EXISTING WINDOW (2no)
to be overhauled
routed to take fineo glazing

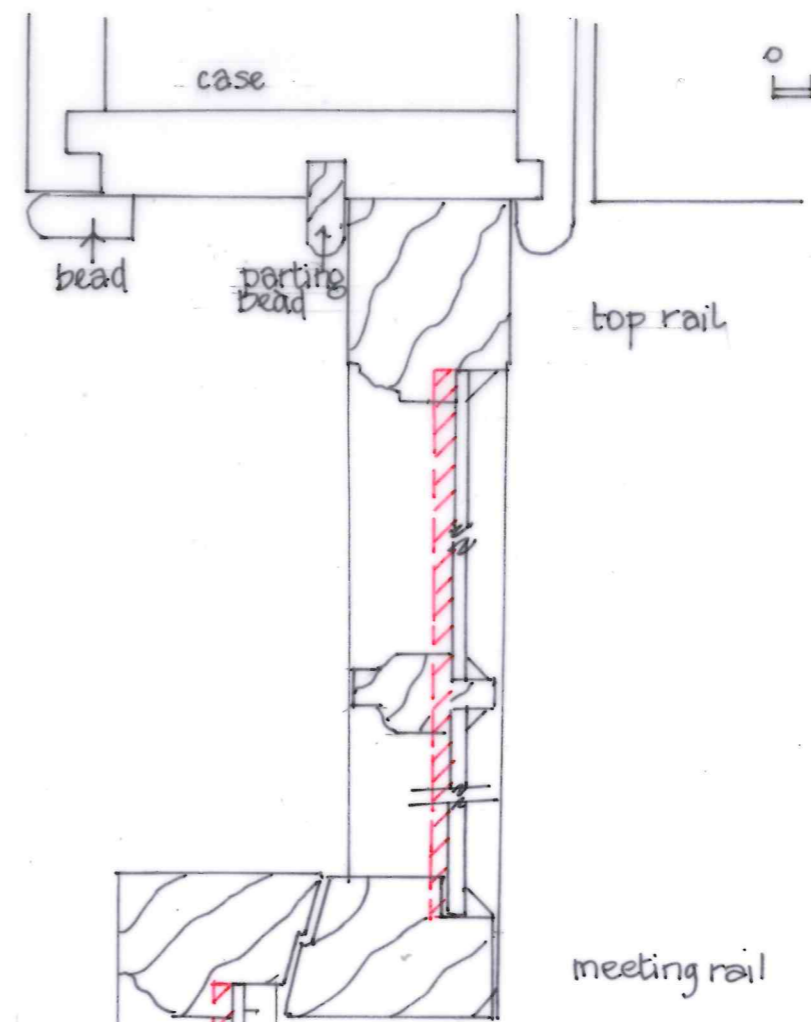
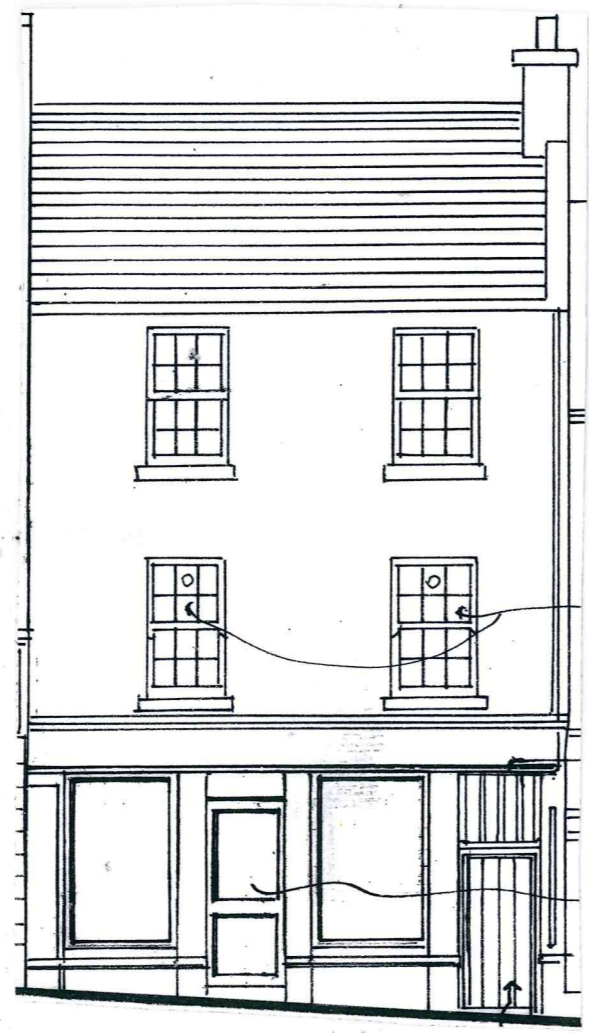
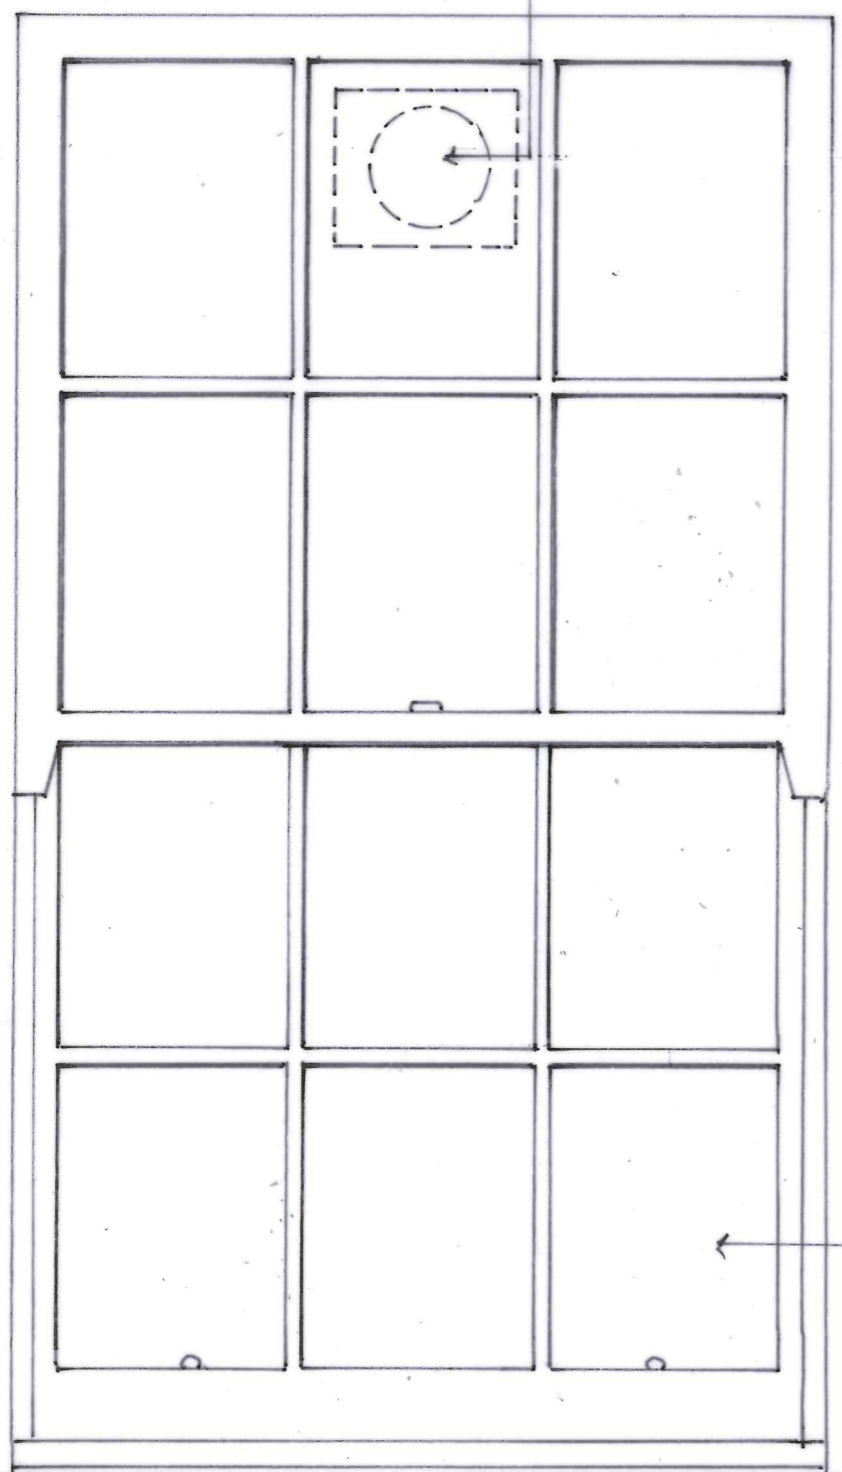
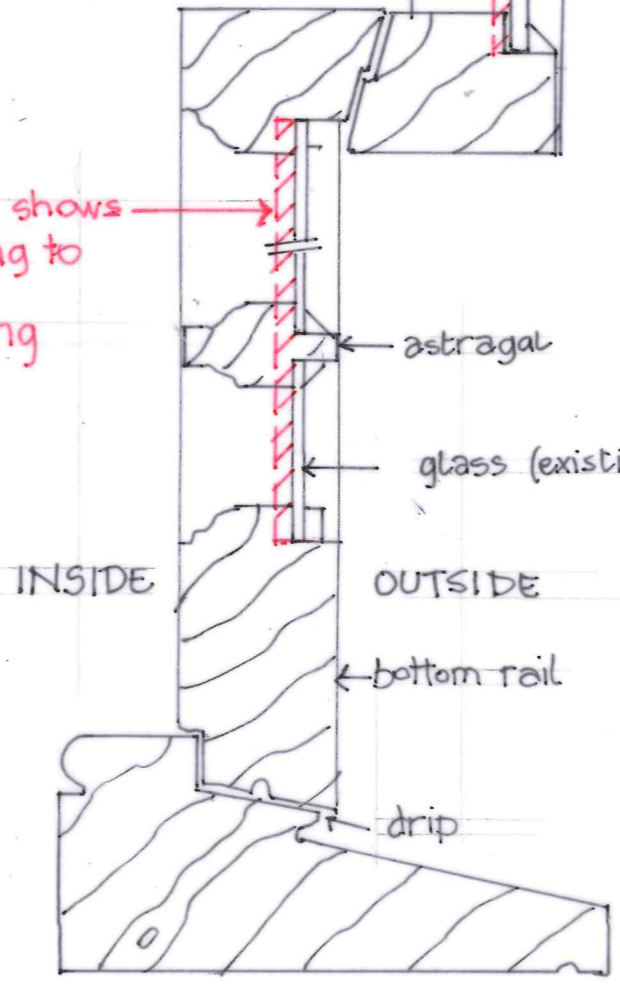
existing
Vent axia removed

red hatching shows
timber routing to
take 6-7mm
fineo glazing

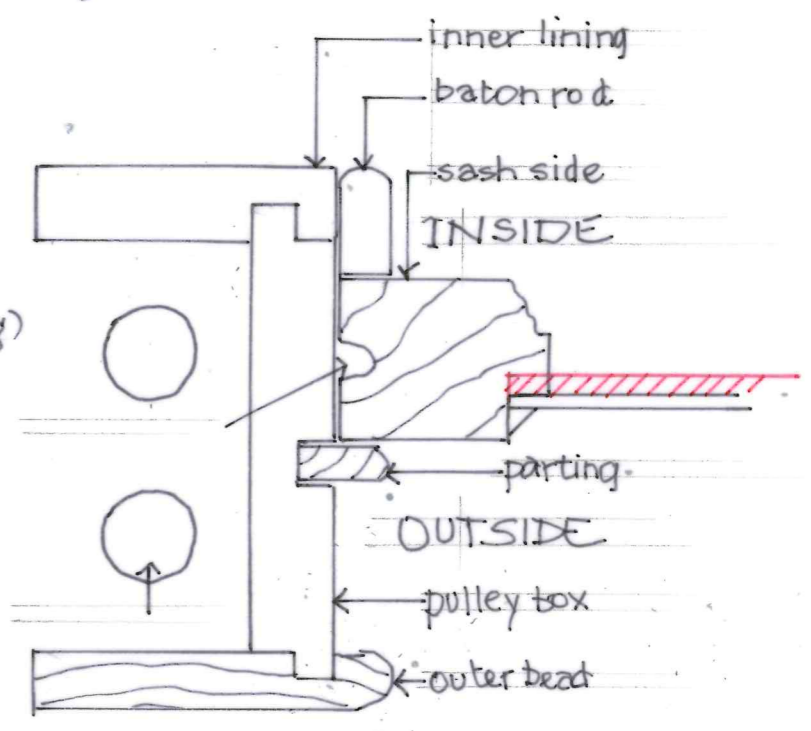
meeting rail
